VILLAGE OF GERMANTOWN
N112 W17001 MEQUON ROAD
GERMANTOWN, WI 53022

MEETING:	PLAN COMMISSION
DATE AND TIME:	MONDAY, MARCH 13, 2017 6:30 p.m.
LOCATION:	Germantown Village Hall Board Room

SITE PLAN REVIEW

3/13/17 Plan Commission Meeting

GUTBROD BUILDING
LANDSCAPE PLAN
DATED: FEBRUARY 17, 2017

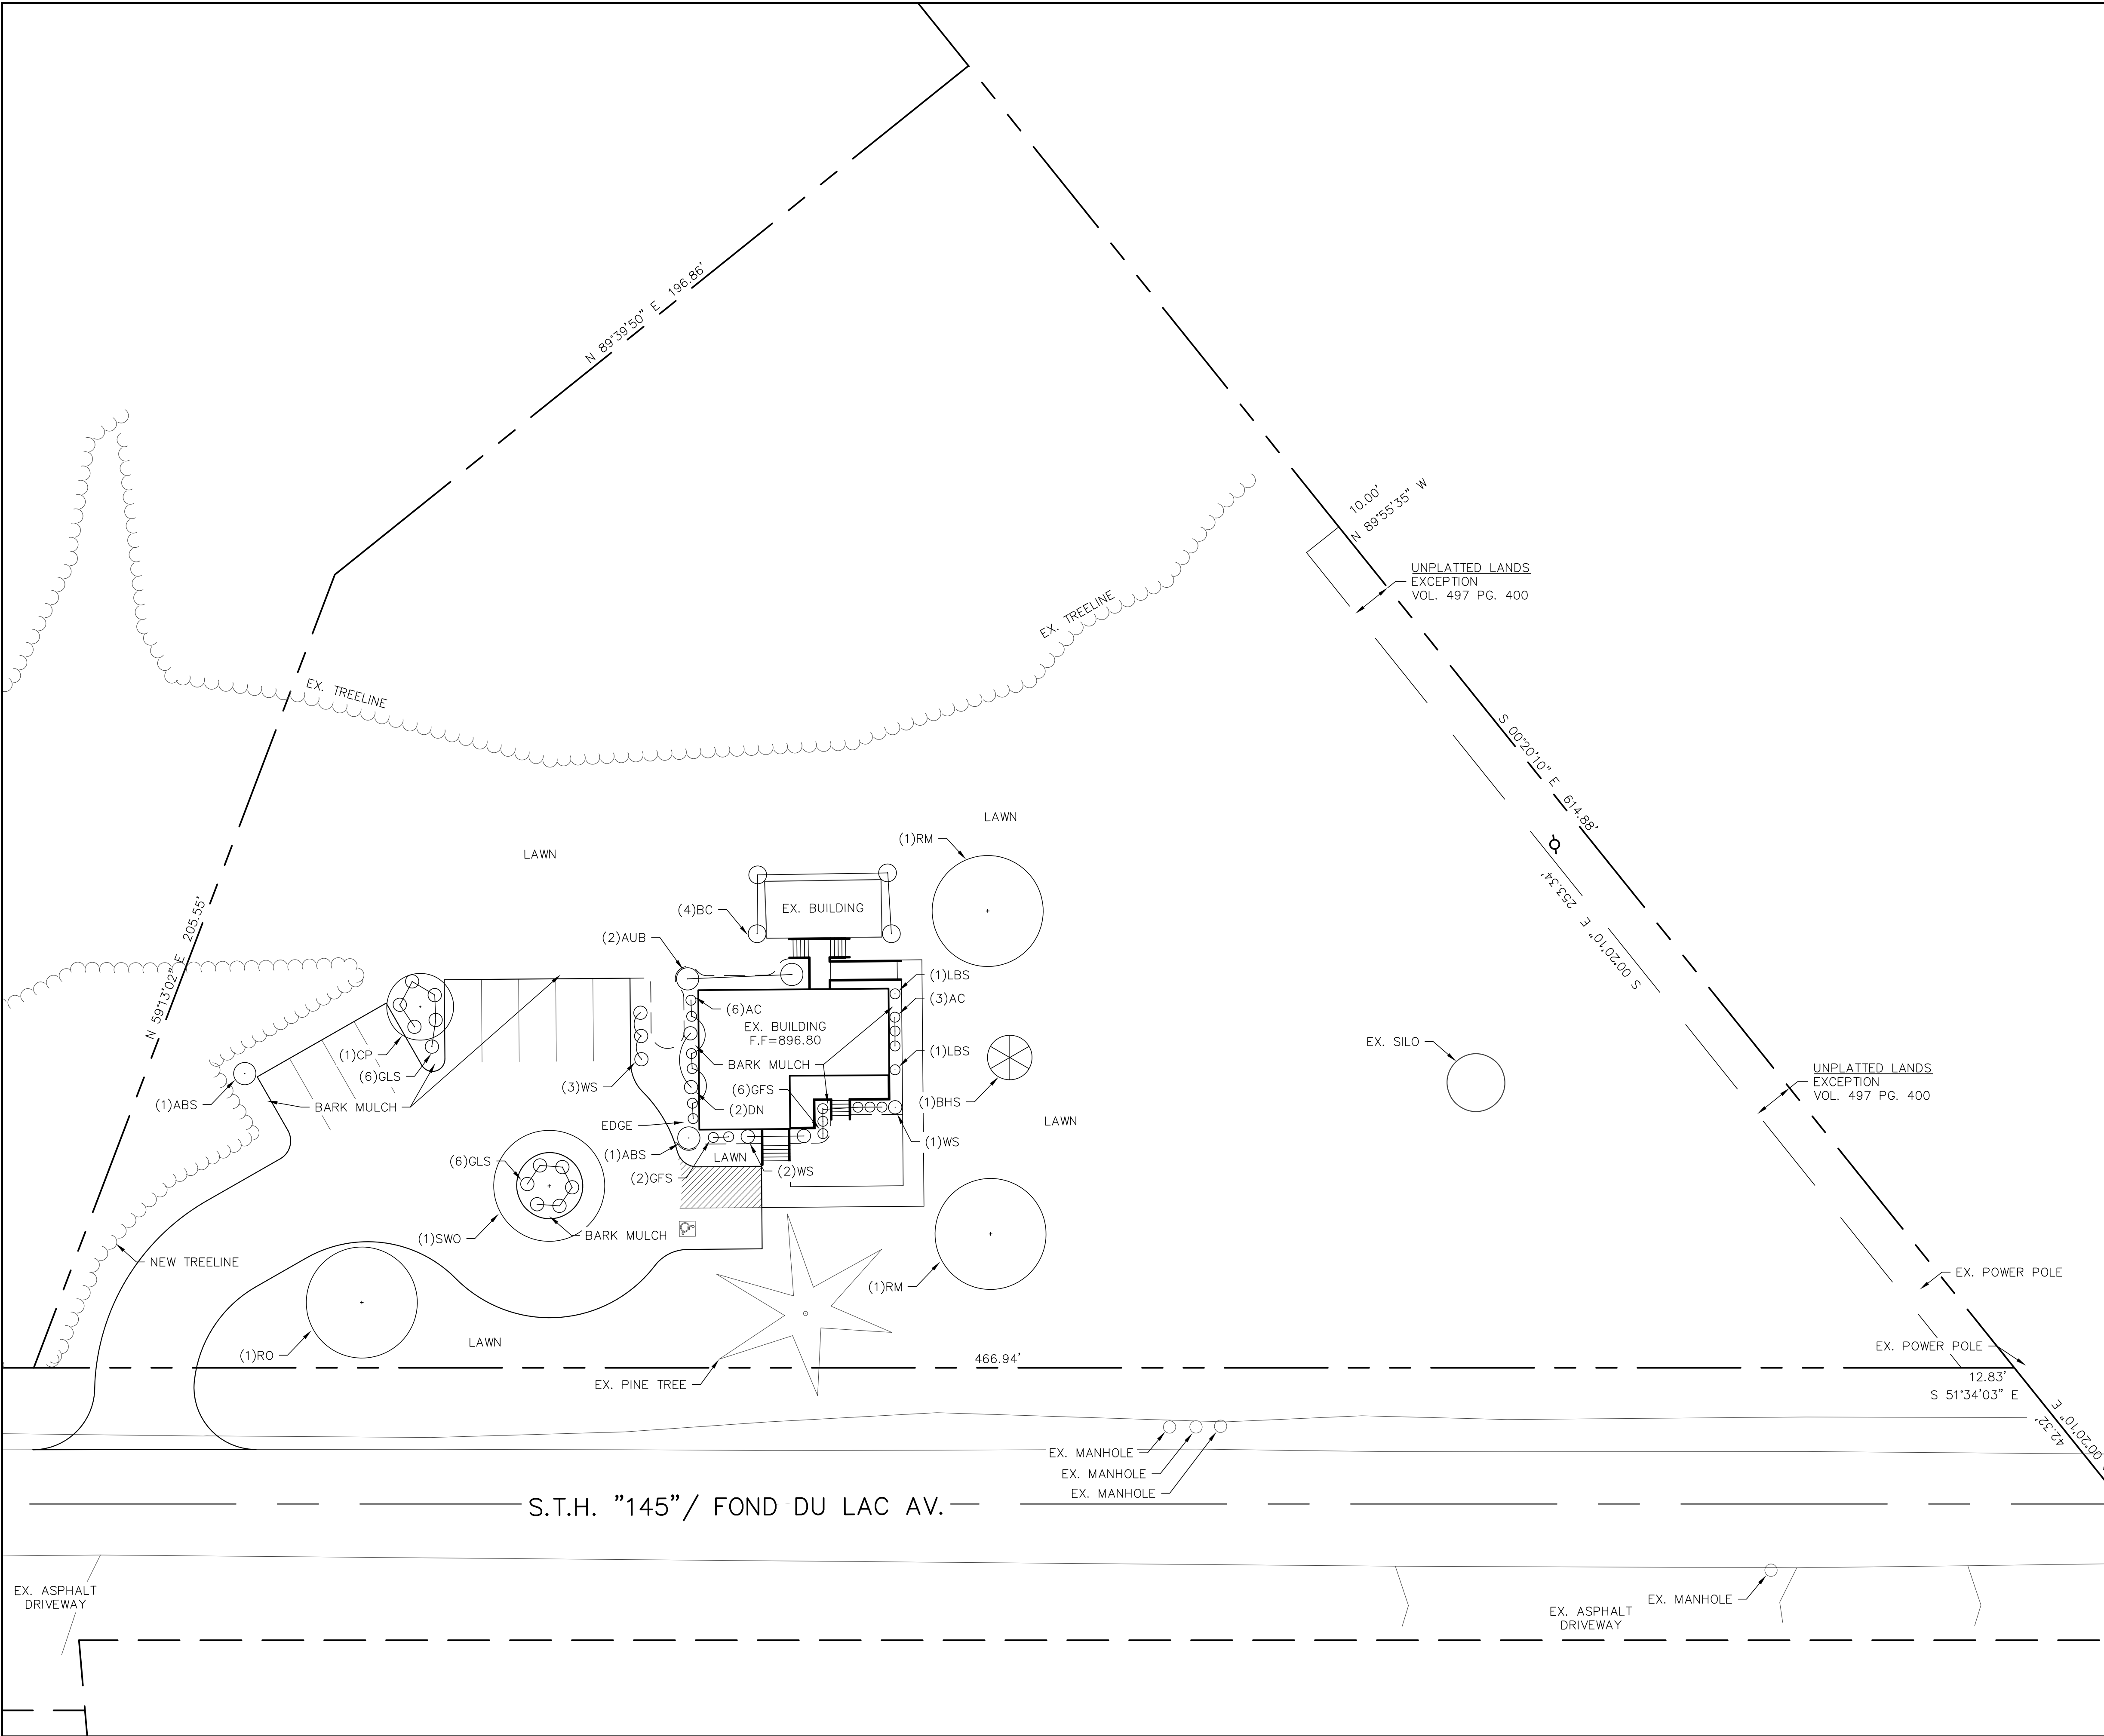
The landscape plan indicates that a significant amount of existing, overgrown vegetation are to be removed along Fond du Lac Ave. While the plan does not specify the amount or type of trees and shrubs to be removed, it's likely that the vegetation is comprised of Buckthorn and other invasive tree and shrub species. The plan indicates that one existing pine tree will be preserved and two (2) new deciduous street trees will be planted between the parking lot and road right-of-way. With 466' of road frontage, a minimum of nine (9) street trees are required along the road. Unless the owner is able to identify and protect additional, existing deciduous trees along Fond du Lac Avenue, an additional seven (7) street trees should be planted in the street yard along the road right-of-way. A revised landscape plan indicating the type and number of additional street trees shall be prepared and submitted to the Village Planner for review and approval prior to issuance of an occupancy permit.

2. An additional seven (7) street trees (min 2½" dia) should be planted in the street yard along the Fond du Lac Ave right-of-way. A revised landscape plan indicating the type and number of additional street trees shall be prepared and submitted to the Village Planner for review and approval prior to issuance of an occupancy permit.

SITE PLAN - BUILDING FOOTPRINT REVISIONS

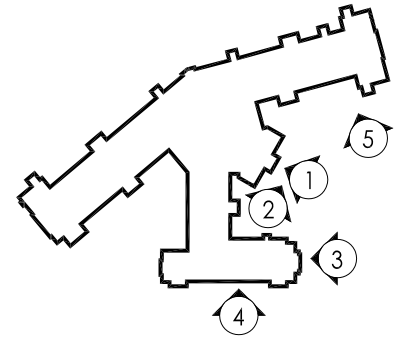
As shown in the attached site plan comparing the approved vs. proposed building footprint (dated March 13, 2017), the overall building size is being reduced from 210,400 sqft to 204,950 sqft (2.6% reduction).

The **building size has been reduced** thru revising and combining some public spaces, eliminating additional conference rooms and parlors, and combining and co-locating office and staff spaces. Secondary savings in areas were seen in shortening corridors and circulation spaces. See the attached overlay line on the July 2016 Site Plan.

1. Revised building elevation/architectural plans consistent with the supporting documents dated March 13, 2017 shall be prepared and submitted to the Village Planner for review and approval prior to issuance of a building permit.
2. A revised landscape plan indicating the type, number and location of the additional landscaping to be provided shall be prepared and submitted to the Village Planner for review and approval prior to issuance of a building permit.

4 MEMORY CARE/ ASSISTED LIVING - SOUTH ELEVATION - July 5, 2016
 $\frac{1}{32}'' = 1'-0''$

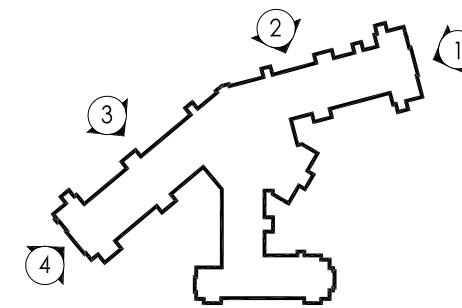
As shown in the attached renderings comparing the approved vs. proposed building elevations (dated March 13, 2017), the amount of stone, siding and glazing is being changed. The attached table indicates that the amount of stone on the approved plans is being reduced from 21,200 to 12,475 sqft (a 41% decrease). The amount of stone on all elevations will be reduced from 36% to 23% of all wall elevations.

To compensate, more window glazing has been added (21% to 29% of the total wall elevations) and more siding has been added (43% to 48% of the total wall elevations). Presbyterian Homes has also indicated that additional landscaping will also be provided in the vicinity of the building where the reduction in stone would be more visible.

The **stone material selection has been revised** to be true, quarried, full-bed installed stone, in lieu of the manufactured cultured stone presented in July as it is more cost effective from a labor side.

In exchange for reducing stone quantities, windows have been added or increased in size, and landscaping trees have been added to the areas where stone reduction is visible from the public way.

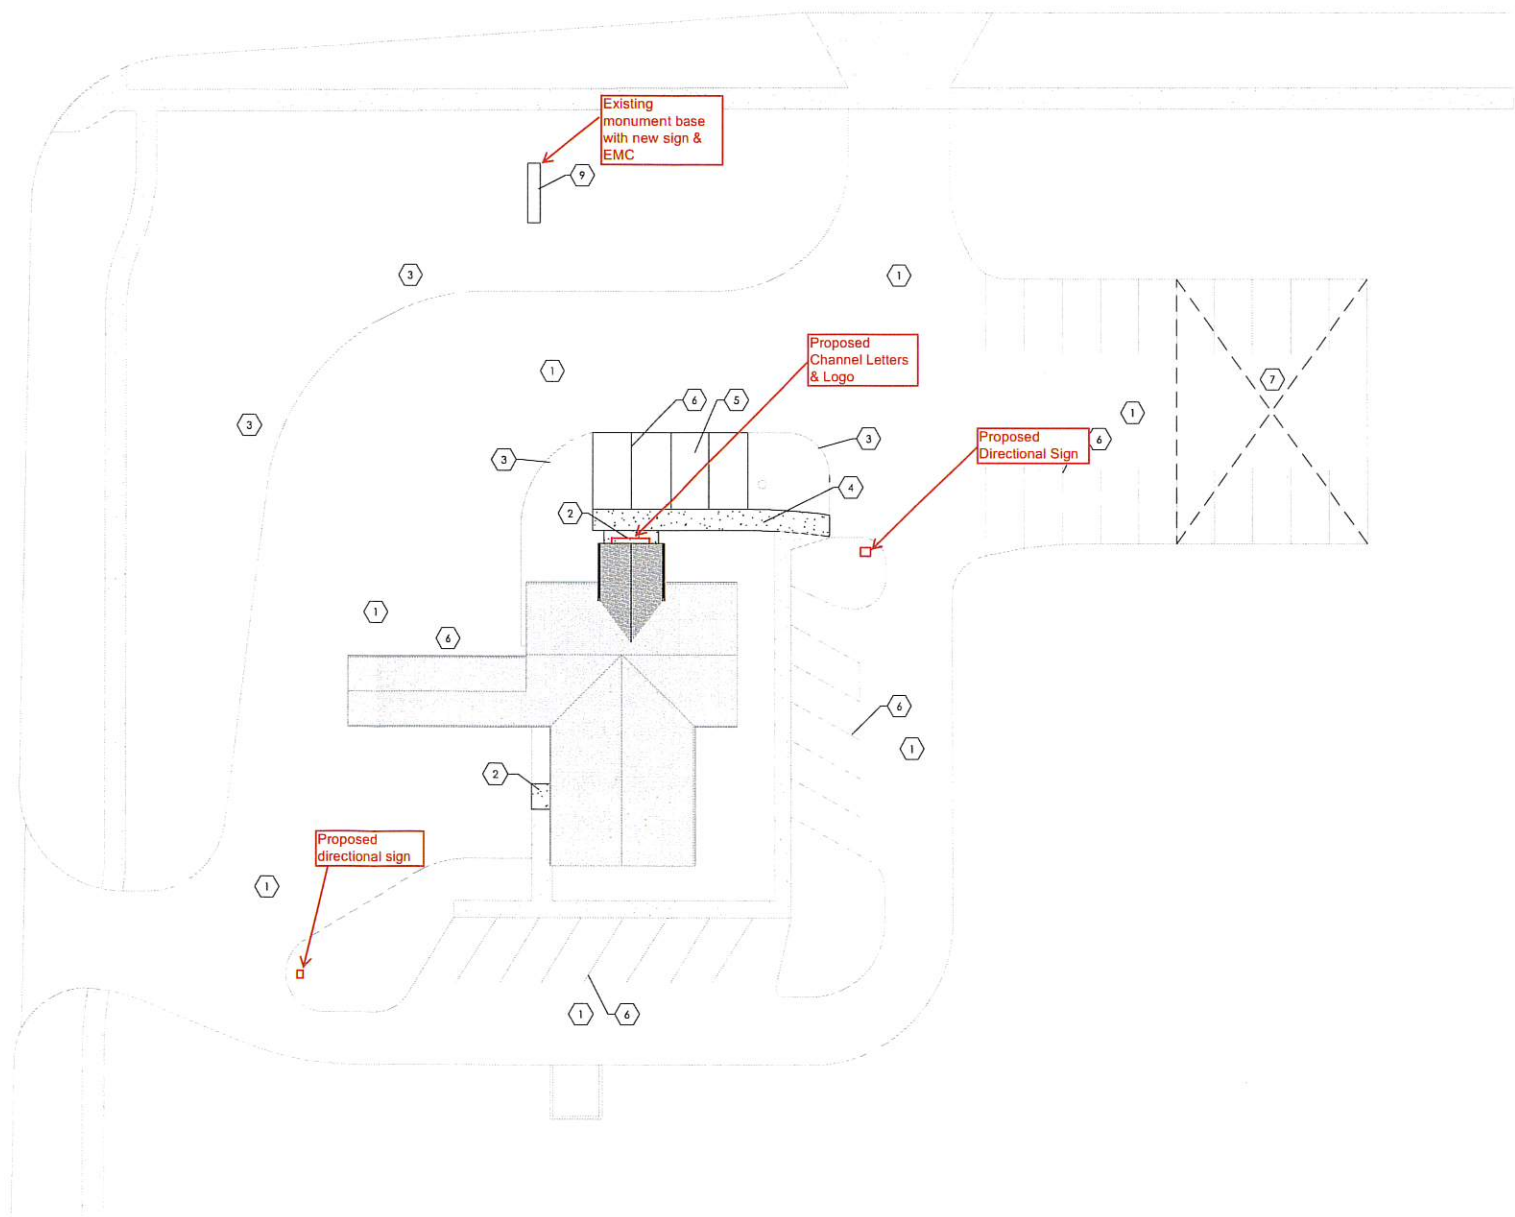
The proposed wall, directional and monument signs sign meets the Village's area and other dimensional requirements for each specific type of sign, including the requirements for base materials except for landscaping. While the existing monument sign has some landscaping around the base, it is insufficient and does not meet the current requirements. A revised landscape plan indicating additional landscaping meeting the Village's monument sign landscaping requirements needs to be prepared and submitted to the Village Planner for review and approval.

6. Additional landscaping shall be installed around the base of the monument sign in compliance with the Village’s monument sign landscaping requirements under 17.46(7). A revised landscape plan shall be prepared and submitted to the Village Planner for review and approval prior to issuance of a building/electrical permit for the monument sign.
